# Apache Powder Superfund Site

St. David, Arizona

## REMEDIAL DESIGN ACTIVITIES UPDATE AT APACHE POWDER SUPERFUND SITE

### CHANGES TO THE RECORD OF DECISION

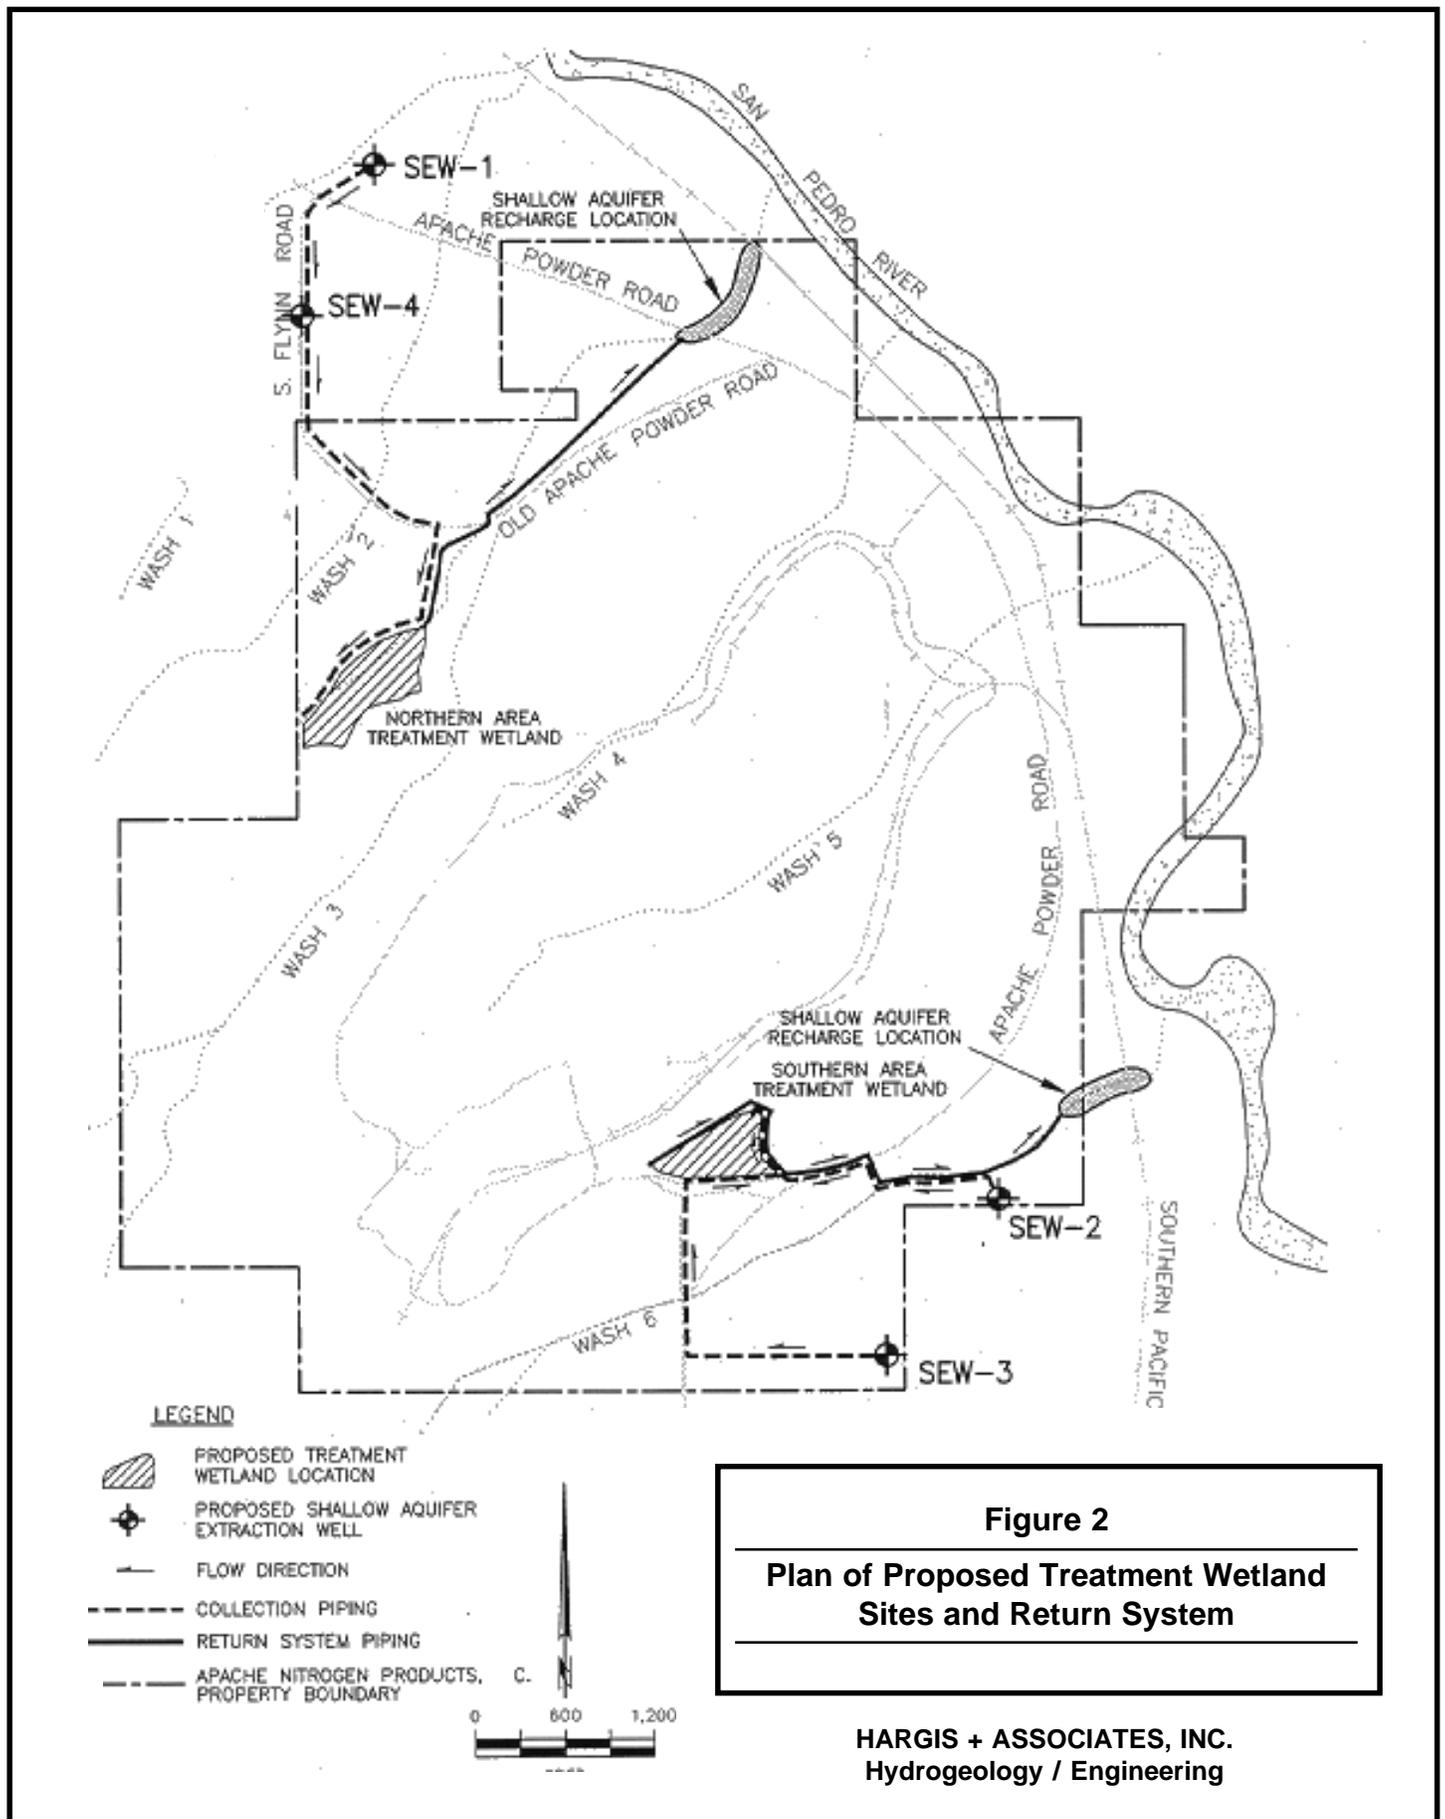
EPA, ADEQ, and ANP agree that the first set of constructed wetlands for treating the shallow aquifer should be located in a relatively "stagnant" portion of the shallow aquifer north of the ANP facility. This is near the area where the concentration of nitrate in the shallow aquifer is the highest and where the groundwater circulation is low. It is in the vicinity of shallow aquifer monitor wells MW-17 and MW-18 and is referred to as the "northern area." Siting the first set of constructed wetlands in this area will capture the nitrate-contaminated shallow aquifer plume as it migrates north. It will maximize treatment in the area with the highest levels of nitrate where several residences are located and where there is the most potential for new residential develop-

ment (Figure 2). This first set of wetlands would be constructed during the spring of 1997.

A second set of constructed wetlands will, if needed, be sited in the southeast corner of the ANP property to treat both the shallow aquifer in this area and water from the adjacent perched groundwater zone together (Figure 2). This area is another "stagnant" portion of the shallow aquifer in the vicinity of monitor wells MW-14 and MW-15 and is referred to as the "southern area." The reasons this area was chosen is because this is where the perched and shallow aquifer converge, the concentrations of nitrate are now very similar in both, and the perched zone was the original source point for the contamination now found in the shallow aquifer. Construction of the southern area treatment wetlands would begin approximately one year after the full-scale operation of the northern area treatment wetlands.

Figure 3  
Conceptual Treatment  
Wetland Design

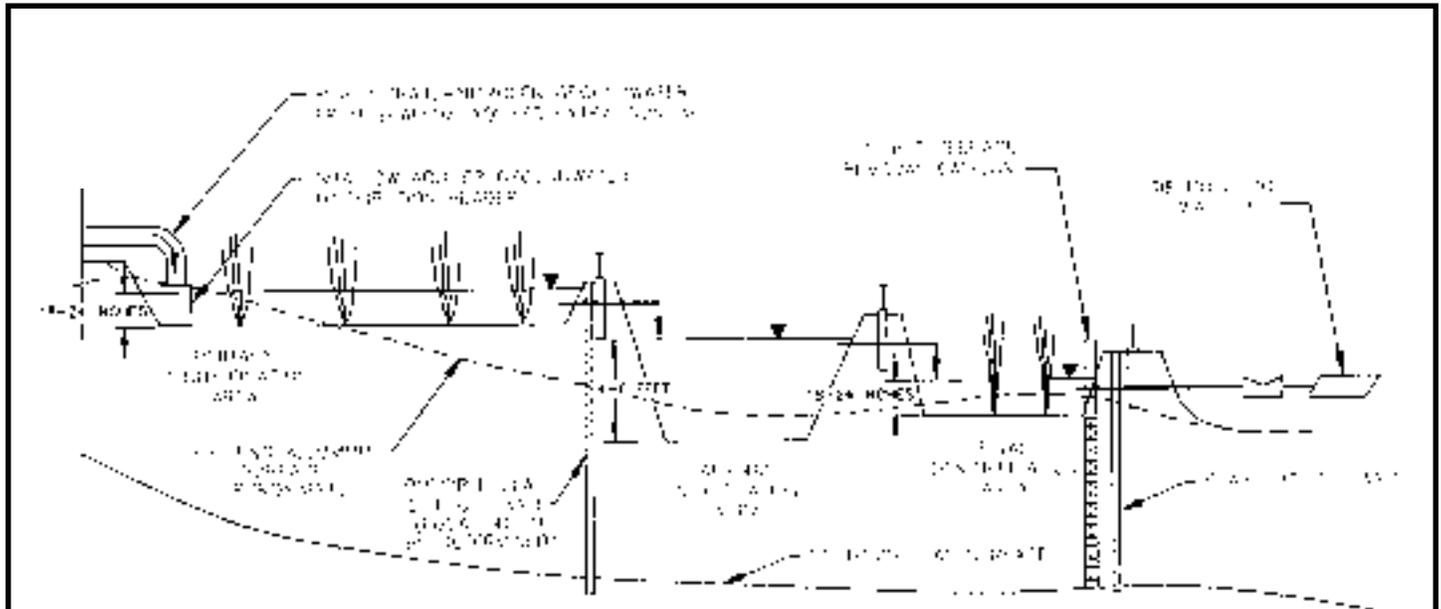
### **#1 Treatment of the Perched Groundwater by Constructed Wetlands in Conjunction with Treatment of the Shallow Aquifer in the Southeast Portion of the Site (Rather Than by a Brine Concentrator)**

The ROD identified two separate groundwater areas for treatment: the perched groundwater zone to be treated in a brine concentrator and the shallow aquifer to be treated by constructed wetlands. Because recent groundwater monitoring data indicate that the perched zone is dewatering very rapidly, and the nitrate concentrations have dropped to levels that could be effectively treated in a constructed wetlands, EPA now advocates treating both the perched zone and shallow aquifer together in constructed wetlands rather than by two separate treatment technologies. Additionally, recent investigations indicate that the remaining perched and shallow aquifer groundwater are very similar in water quality. Because these two areas are hydraulically connected, it now appears more technically and economically feasible to choose extraction locations that will provide for capture of perched groundwater after it has entered the shallow aquifer.

The ROD identified the use of a separate extraction system for pumping the perched groundwater into the brine concentrator. EPA now advocates extracting both the contaminated perched and shallow aquifer groundwater from one point in the southeast corner of the site. Due to Apache Nitrogen Product's (ANP) process wastewaters no longer being released to the evaporation ponds as of April 1995, individual wells are drying up in the perched zone without any additional action being taken. New extraction wells in the perched zone may go dry or only be an efficient pumping location for a limited period of time. The cost of moving these extraction wells or reconfiguring piping would be high. Rather than designing a perched zone extraction system which will need constant changes, it is more cost effective and sensible technically to extract the perched groundwater at the point it enters the shallow aquifer, an estimated

150 feet from the currently defined eastern boundary of the perched groundwater zone. Locating one extraction well and constructed wetlands treatment system in the southeast corner of the ANP facility will accomplish both source control of the perched groundwater zone and treatment of the geographic area of the plume with the second highest levels of nitrate contamination.

**Figure 4**  
**Proposed Shallow**  
**Aquifer Extraction Well**  
**Locations**

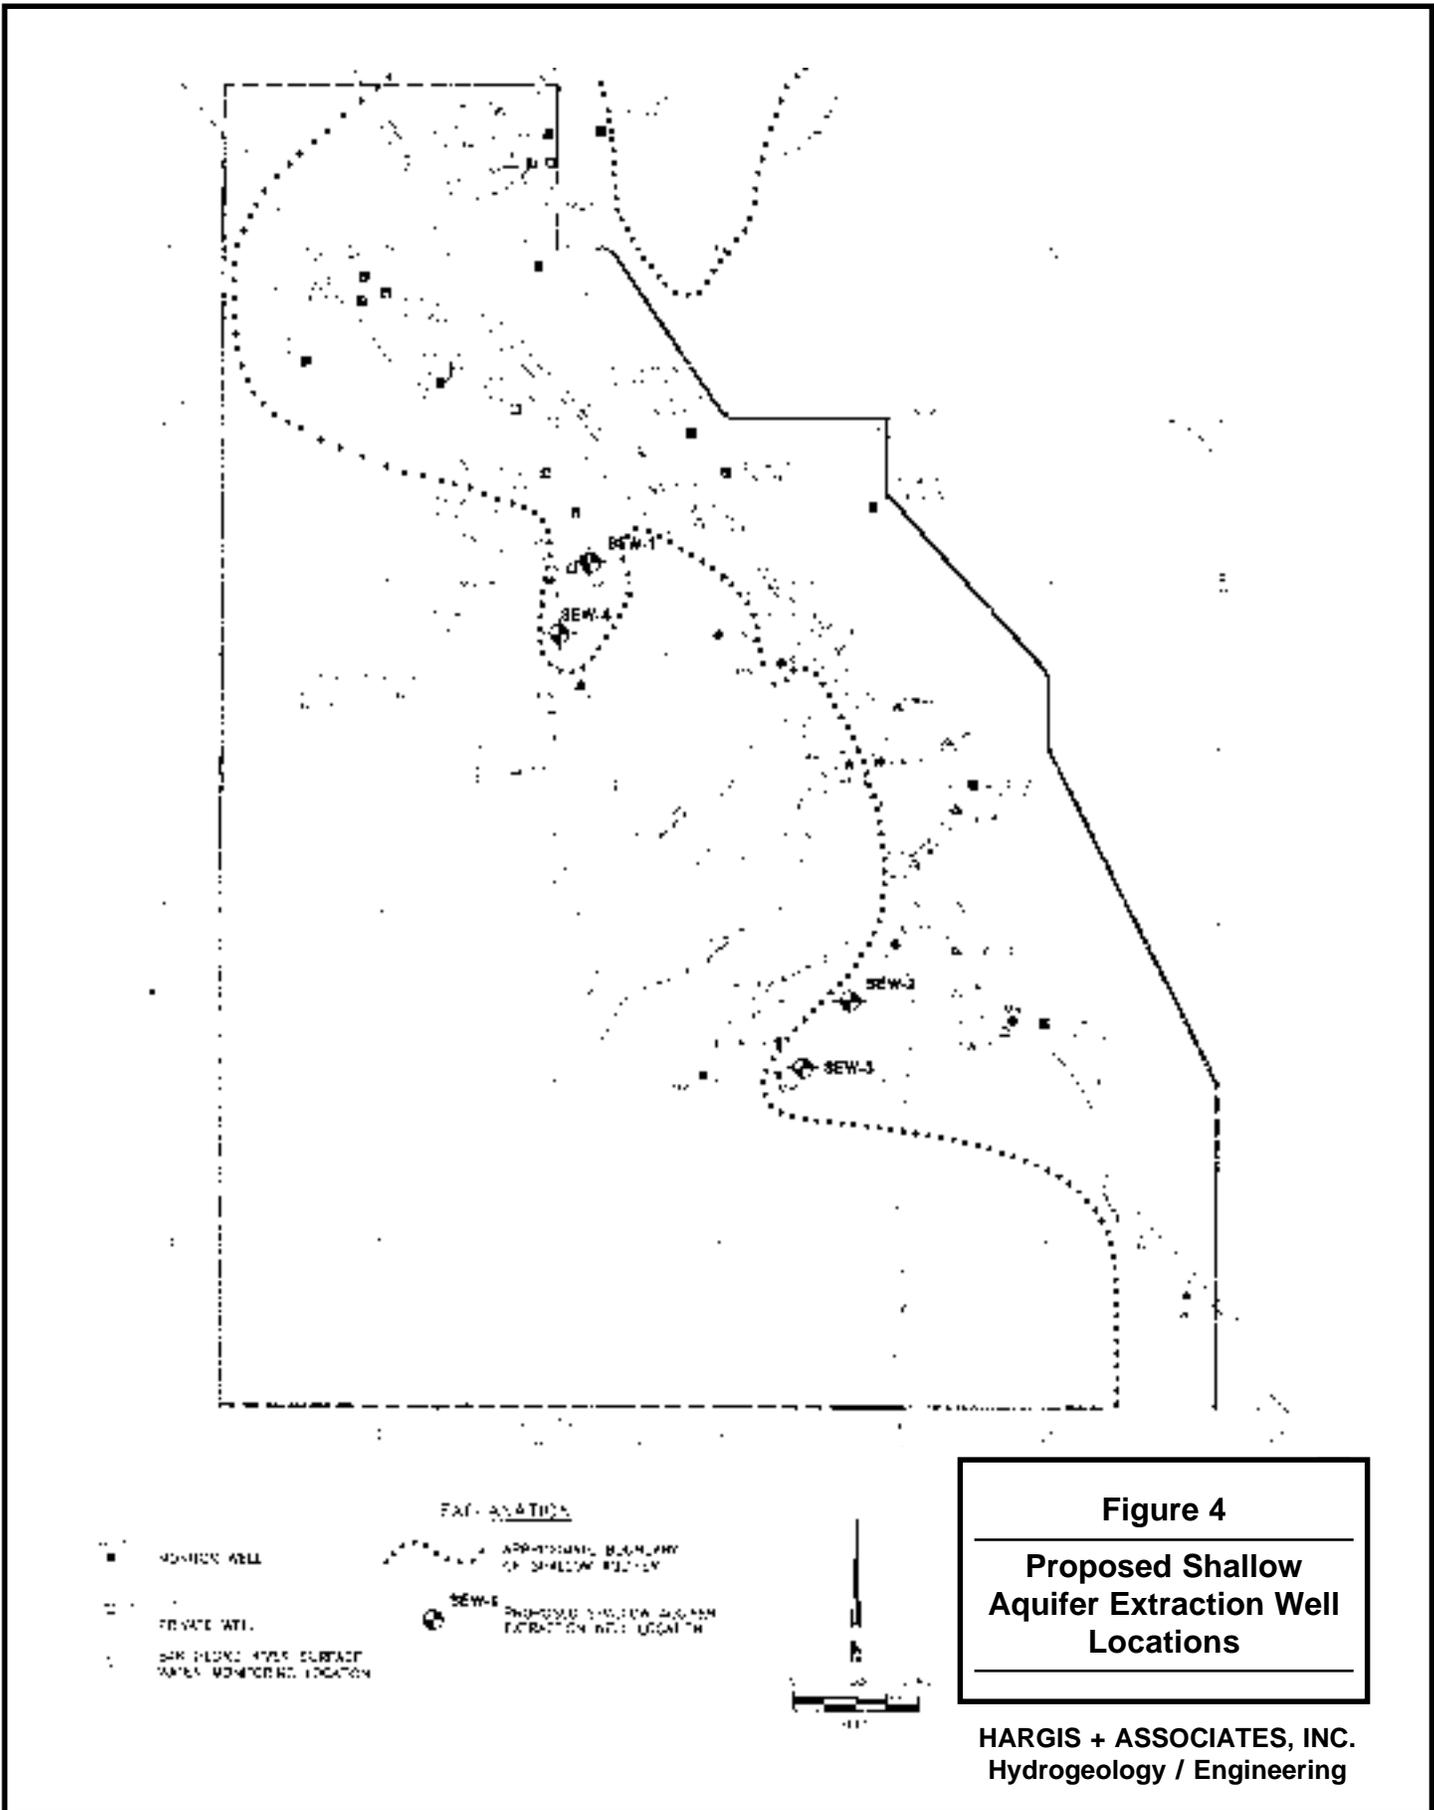
#### **#4 Locate Additional Shallow Aquifer Extraction Wells in Area of High Concentrations of Nitrate to Expedite Groundwater Cleanup**

After the extraction and treatment systems have been operational for several years, groundwater monitoring data may indicate that the initial extraction wells are not sufficient to capture the nitrate-contaminated groundwater plume. If necessary, additional extraction wells may be needed.

Remediation of this area involves treatment of the groundwater through its extraction from the shallow aquifer in two phases. Contaminated shallow aquifer groundwater would be extracted initially from one extraction well located in the vicinity of monitoring wells MW-17 and MW-18 and transported via a pipeline routed along private and county property until it crosses onto ANP property to the northern area wetlands treatment area. After the northern area wetlands have been operating an estimated four years, a review would be conducted to determine if an additional shallow aquifer extraction well and the corresponding pipeline would be required to expedite cleanup of this area.

Remediation of the southern area also involves extraction of groundwater from the shallow aquifer in two phases. The first phase would extract groundwater in the vicinity of monitoring well MW-14. The second phase would extract groundwater in the vicinity of monitoring well MW-15. This would facilitate the overall cleanup of the shallow aquifer while cleaning up any contaminated perched groundwater draining into the shallow aquifer. During the first year or two of operation of the northern area extraction and wetlands treatment systems, monitoring data would be collected to determine if additional monitoring wells or other design modifications are needed for the southern area extraction and wetlands treatment systems.
